SUBJECT: UNIVERSITY OF MISSOURI AT COLUMBIA — AMENDMENT
RE: MANAGEMENT ORGANIZATION (TAC NO. MC1601)

AMENDMENT TO AMENDED FACILITY LICENSE

Amendment No. 33
License No. R-103

SAFETY EVALUATION BY THE OFFICE OF NUCLEAR REACTOR REGULATION

Figure 6.0

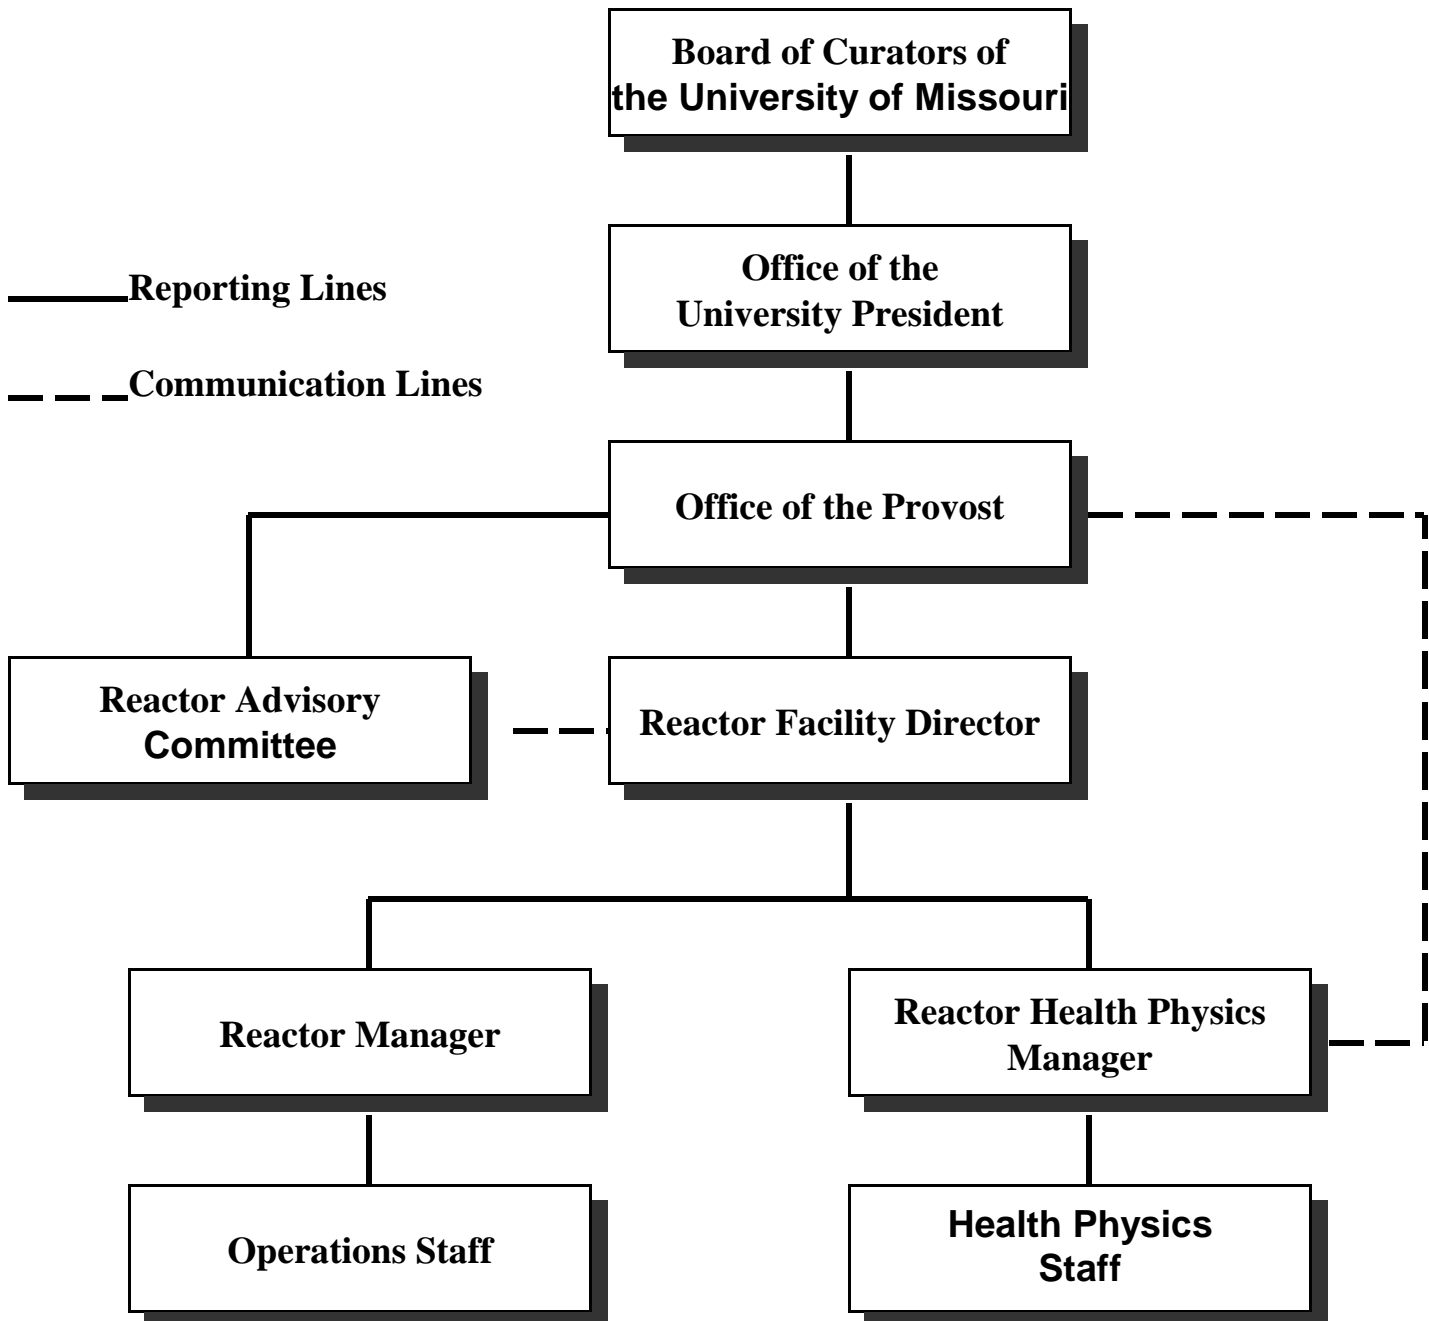
The licensee has submitted changes to Figure 6.0 of the MURR TSs to meet the Order.

Figure 6.0 of the MURR TSs currently has the Reactor Facility Director reporting to the Office of the Provost, which reports to the Chancellor, UMC, who reports to the University President. The University President reports to the Board of Curators of the University of Missouri.

The licensee has proposed removing the Chancellor, UMC, from the reporting chain. The licensee has also proposed that "University President" be changed to "Office of the University President" on the figure.

The NRC staff finds that the proposed changes to Figure 6.0 of the licensee's TSs are consistent with the guidance of ANS-15.1 and meets the requirements of the NRC Order to the licensee. Therefore, the NRC staff concludes that the changes to the licensee's organizational structure are acceptable.
